CITY OF CAMBRIDGE

BOARD OF ZONING APPEAL

BZA Application Form

LOCATION OF PROPERTY: 27 Fayerweather St., Cambridge, MA

EXISTING GARDEN WITH PROPOSED CARRIAGE HOUSE + CURRENT GARAGE (OVERLAY)

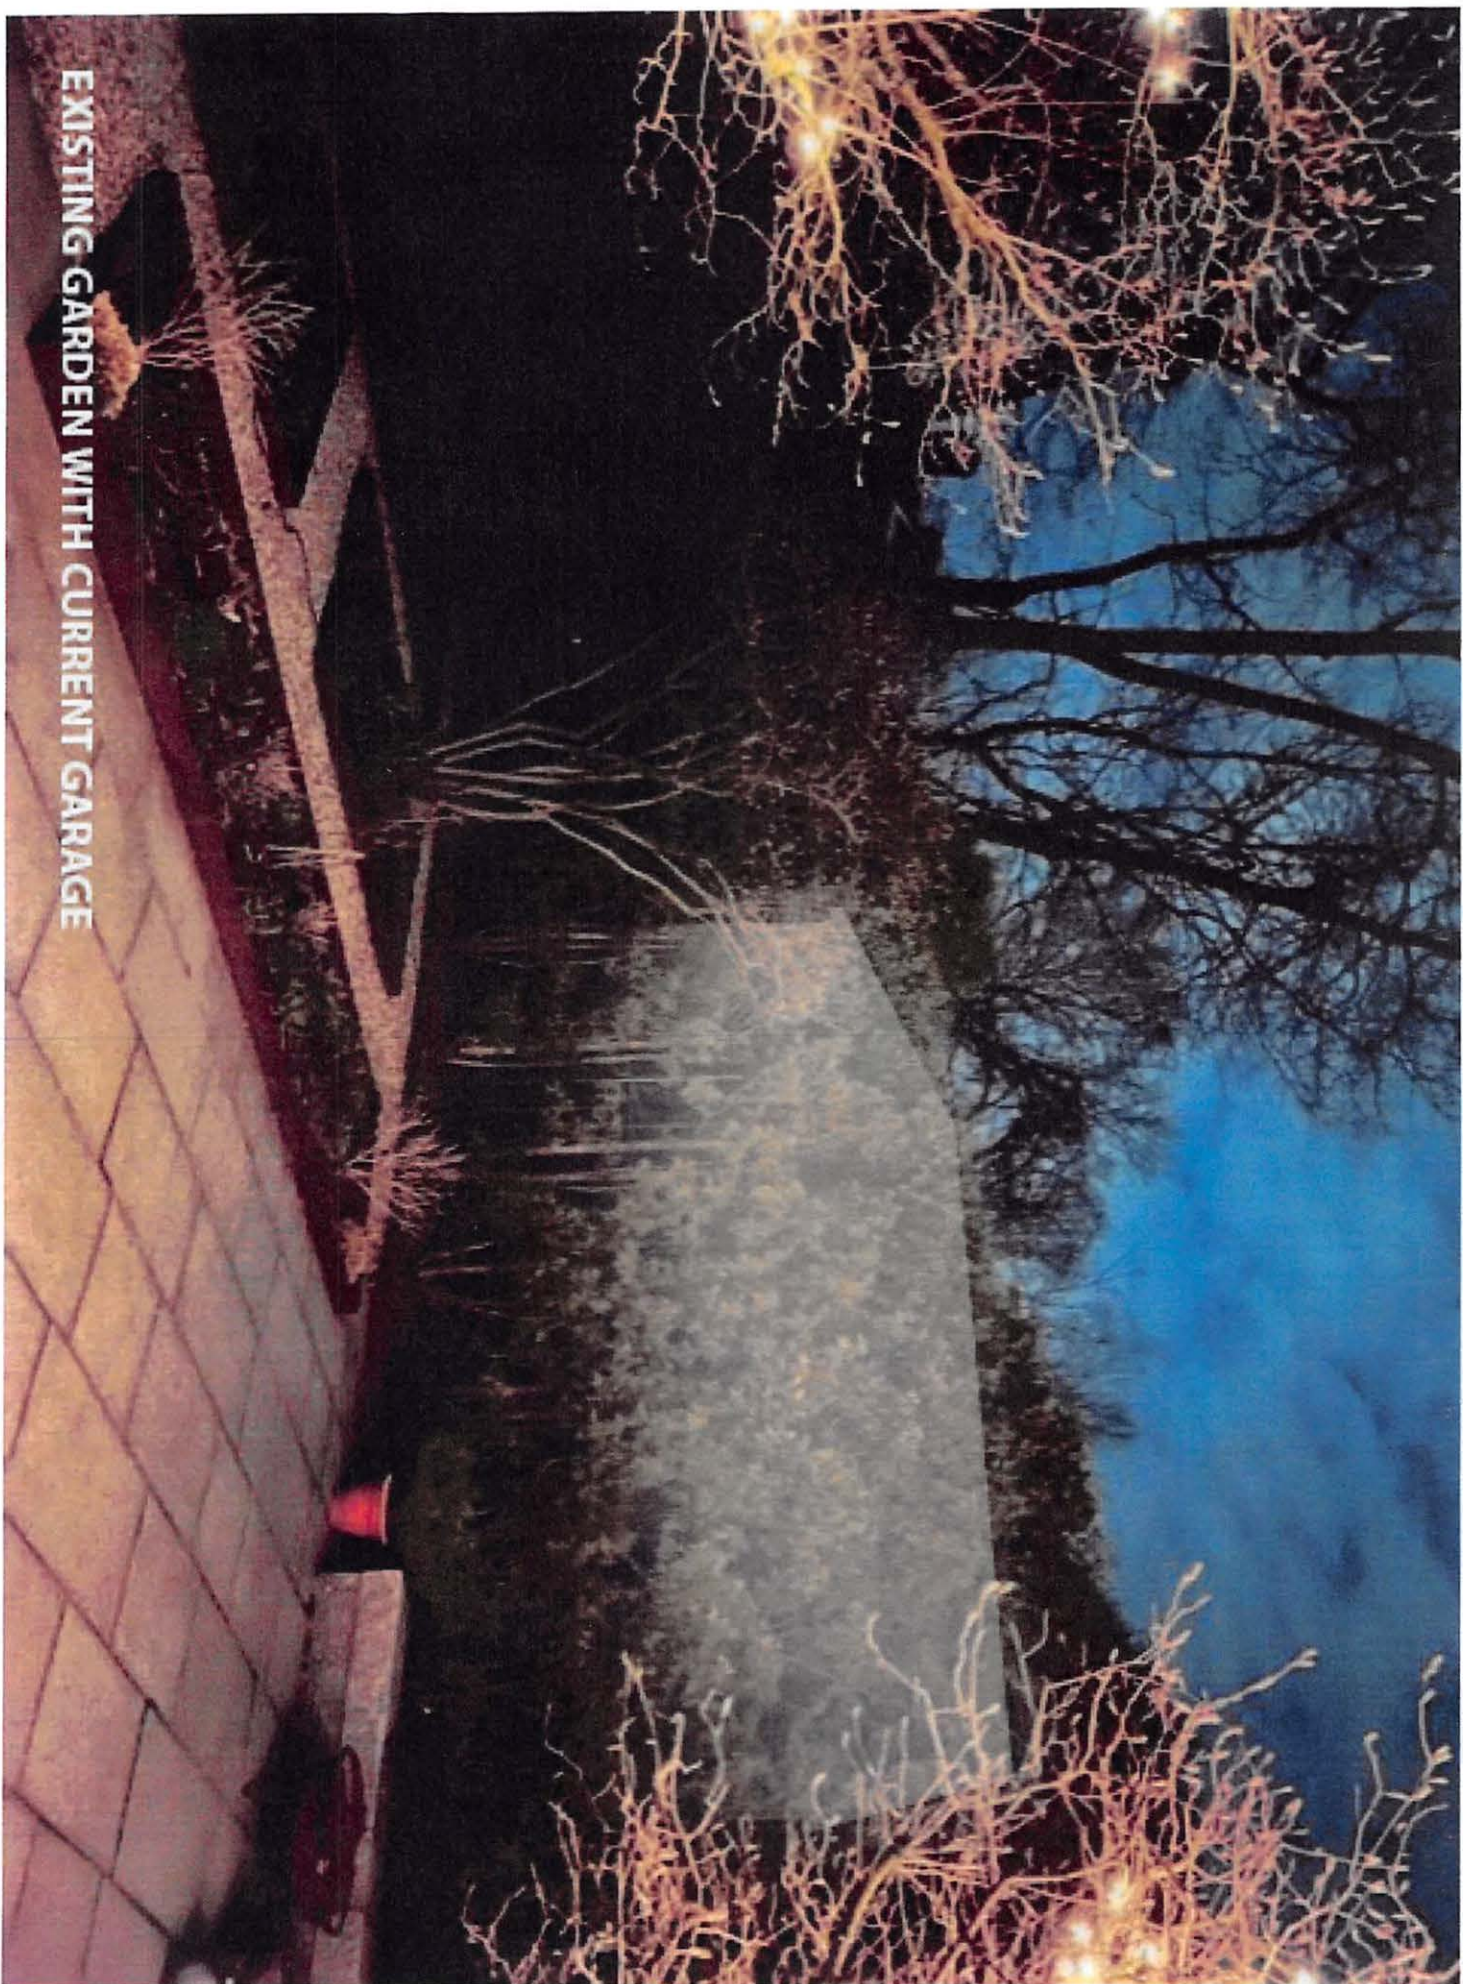
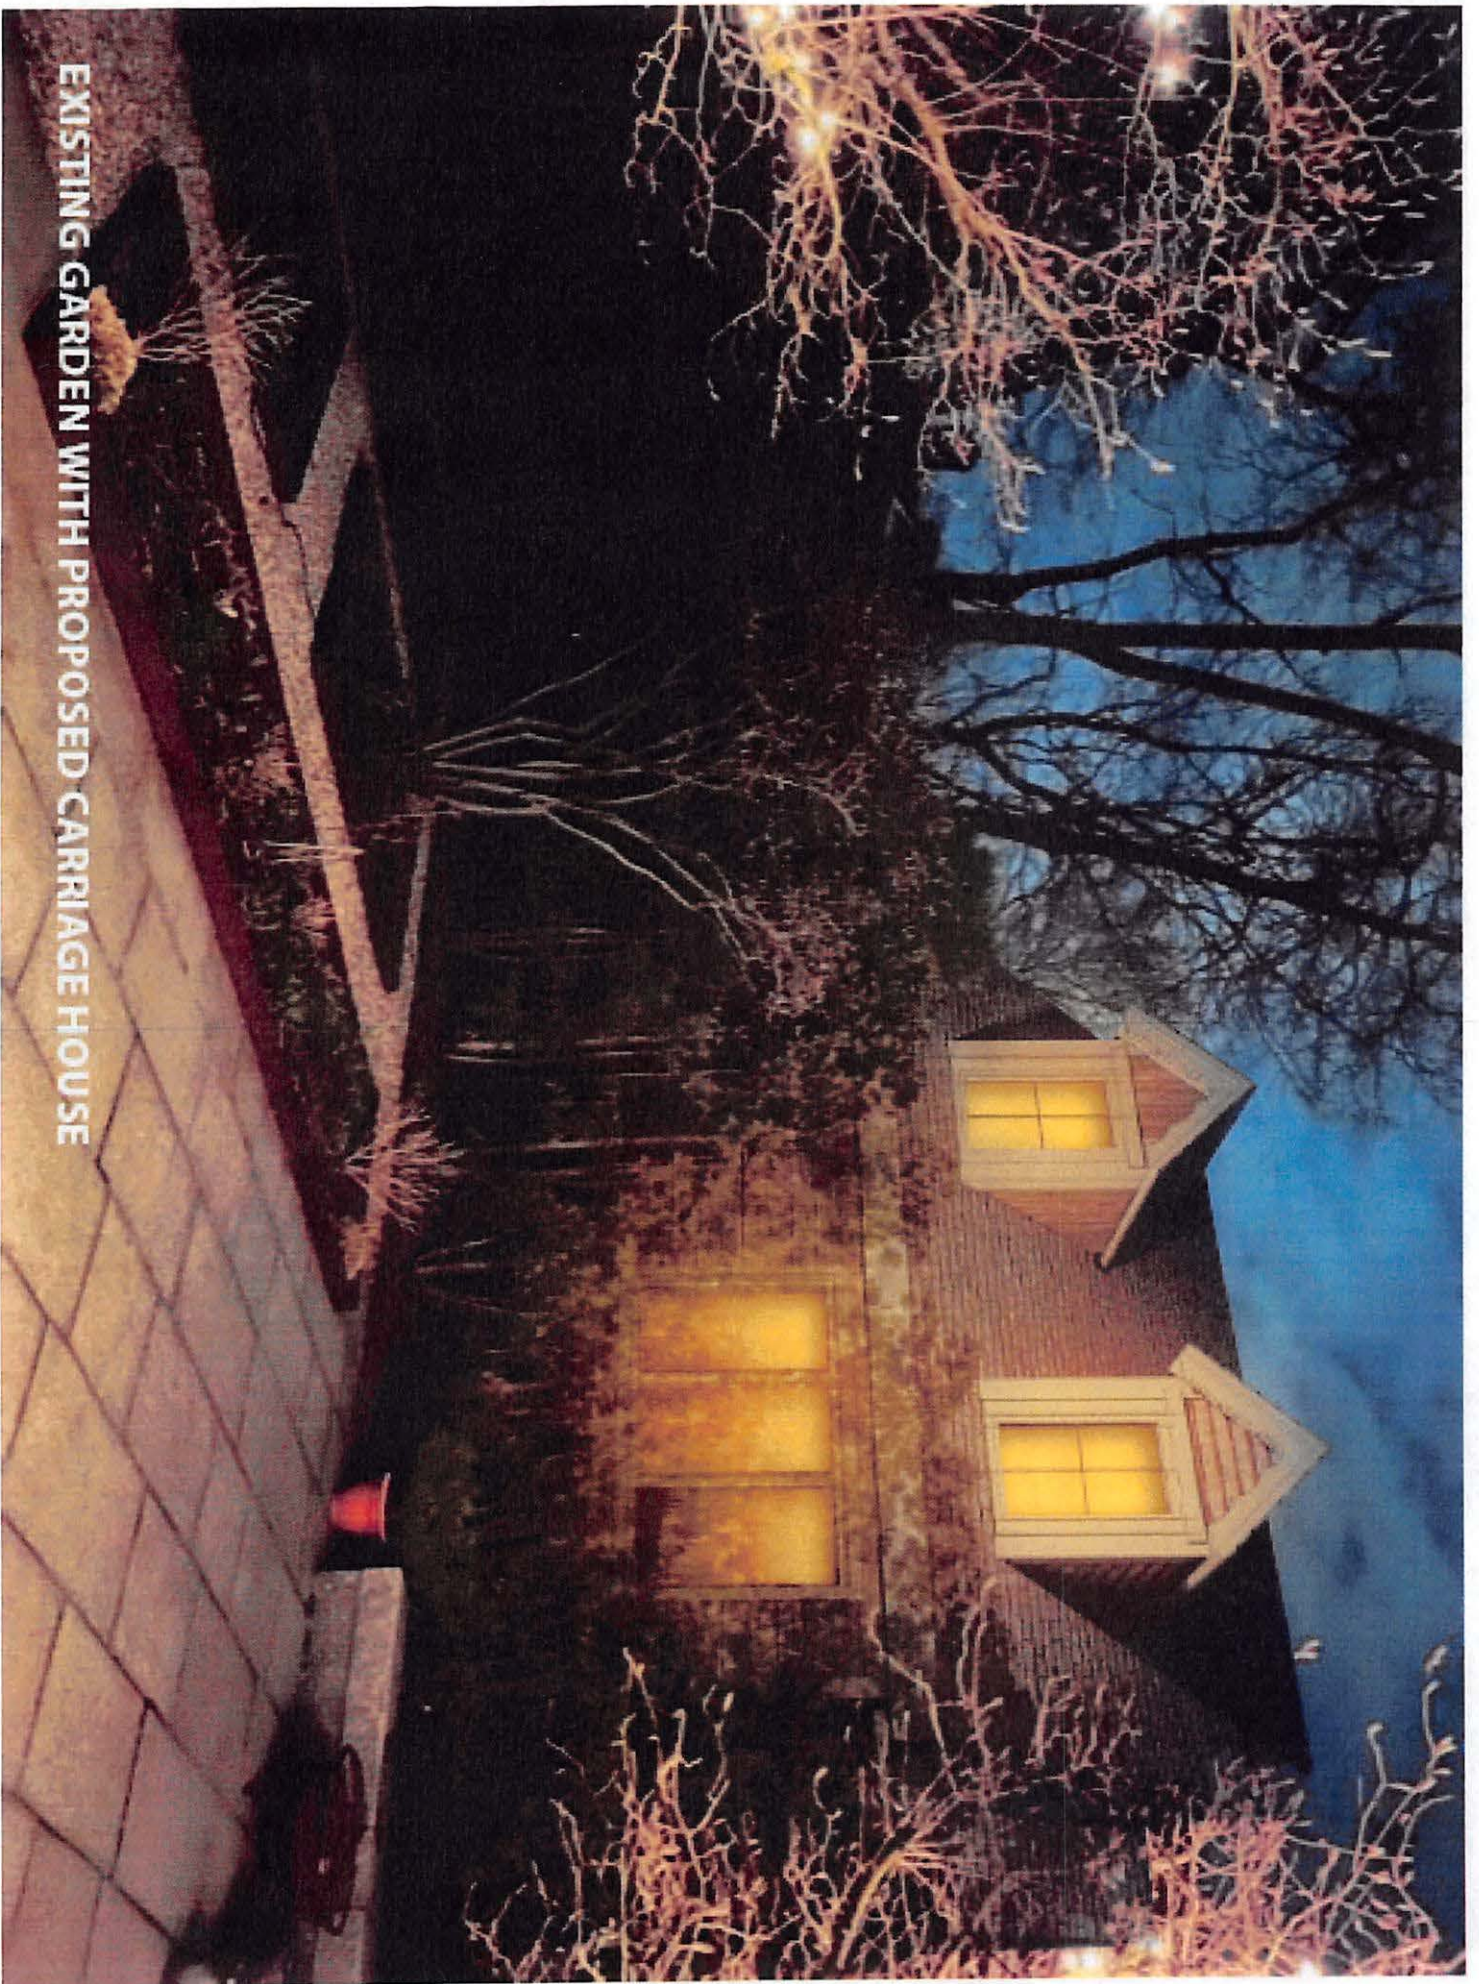
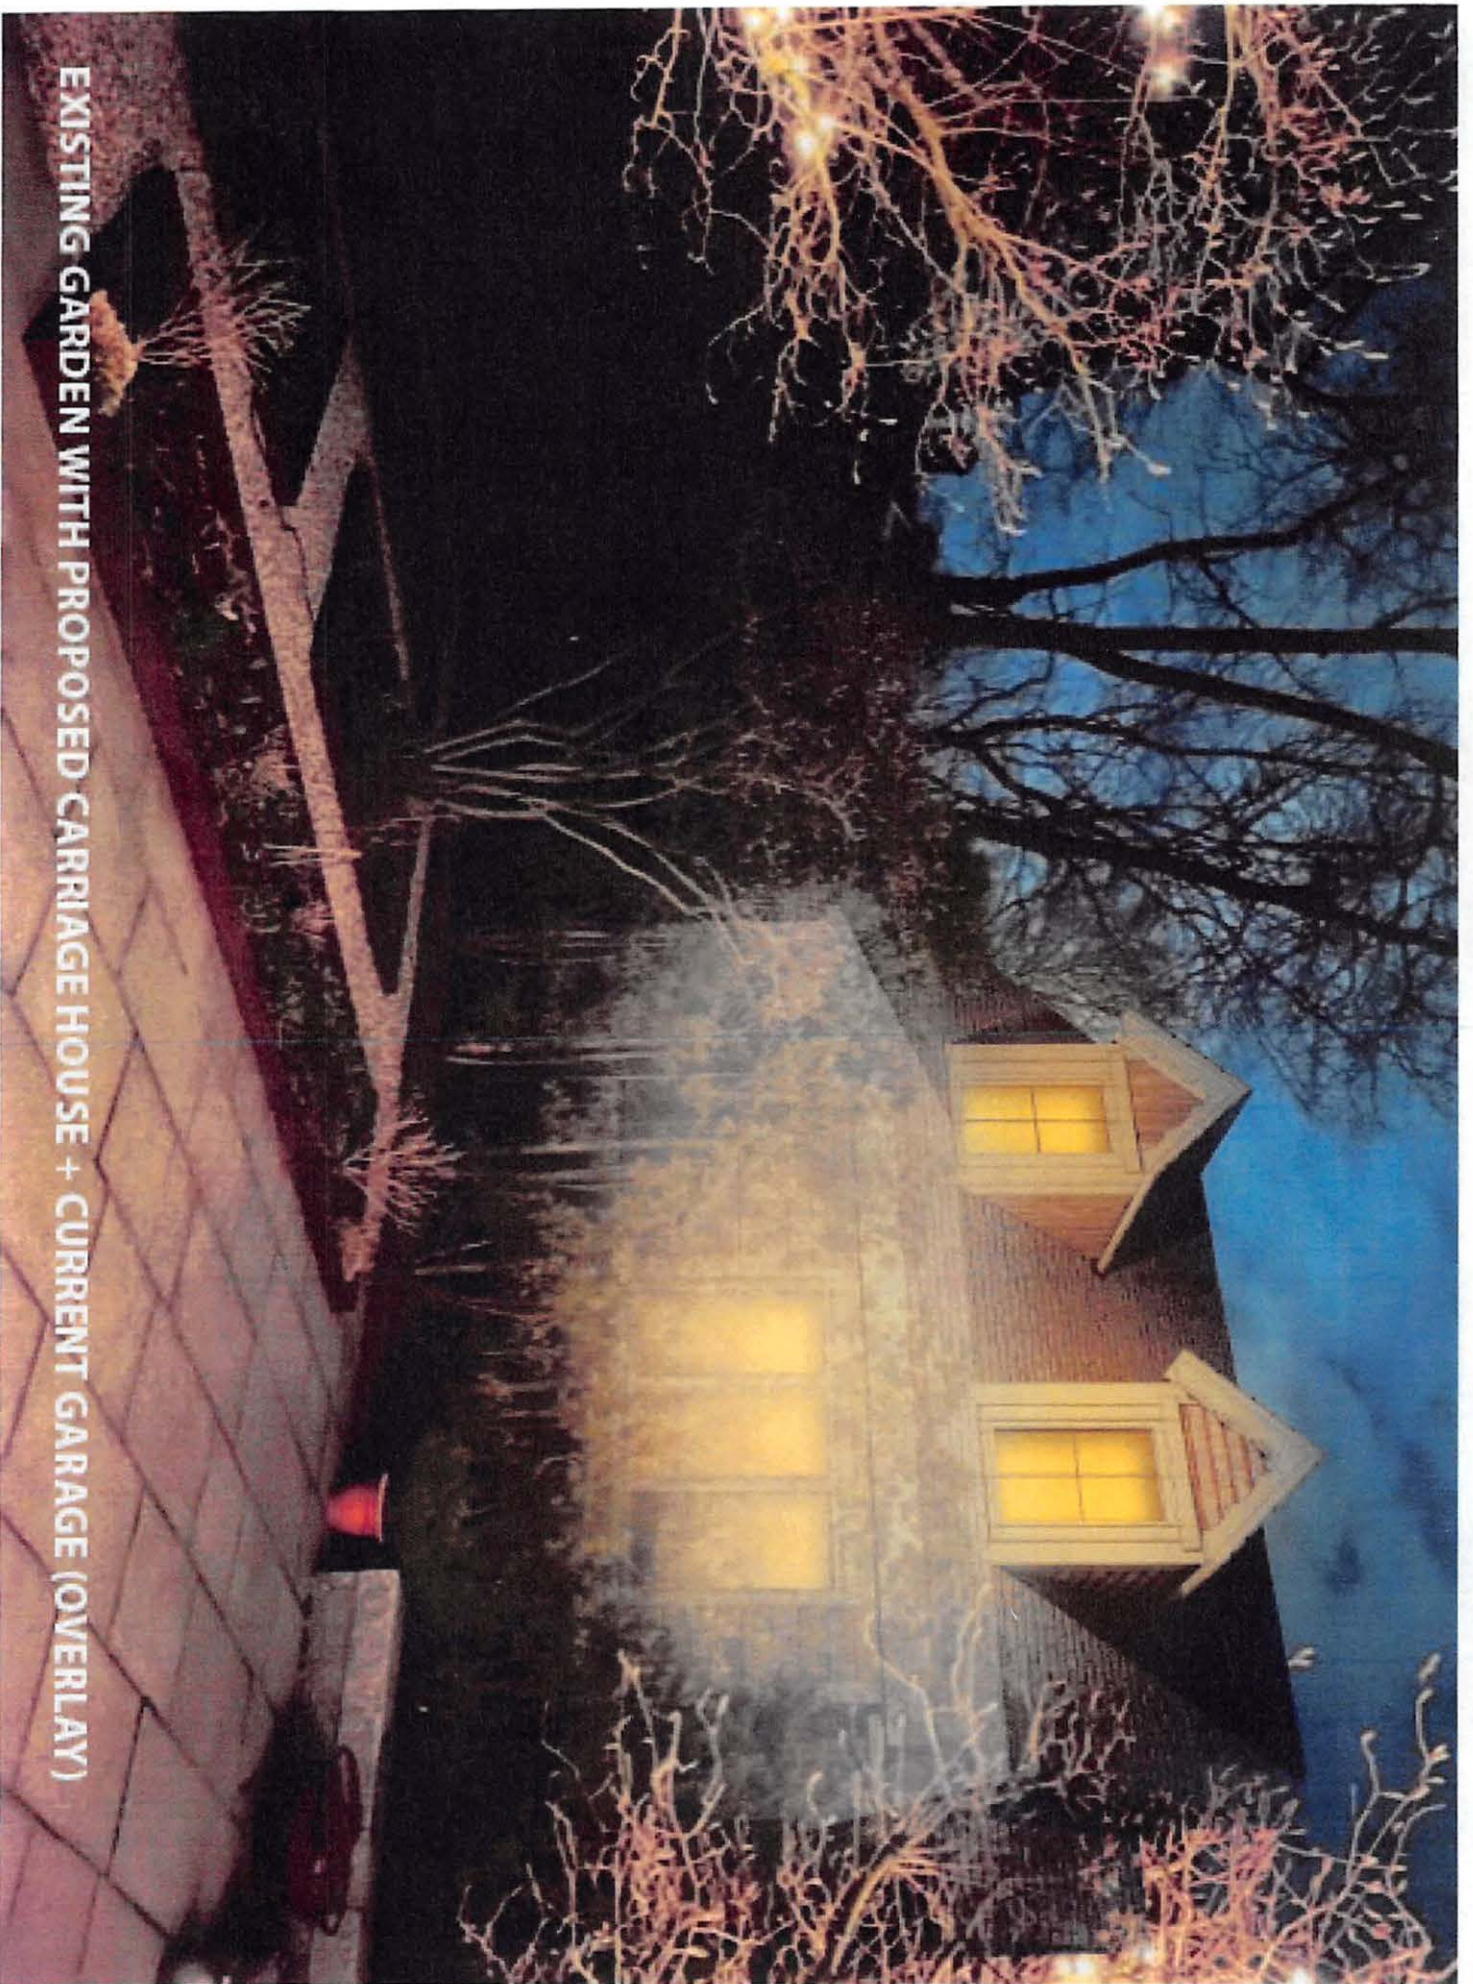
The four panel comparison study that has been prepared by our architect Greg Dennee and submitted to the Board clearly demonstrates the negative impact on our use of our patio and garden. To further illustrate for the Board the adverse effect of raising the height of both the front and rear garages, we engaged the services of our contractor, Kistler and Knapp Builders, Inc. to install four twenty-two foot high poles along the property line. Submitted herewith is a photo of the rear yard patio and garden that depicts the two rear poles placed along the boundary line facing the rear garage, showing the open space that the roof of the proposed accessory building would be filling in. Also submitted herewith are a photo looking from the rear patio toward the two front poles that were placed next on the side of our house facing the front garage, and a photo from the second floor window looking over the existing front garage with the same two front poles in place.
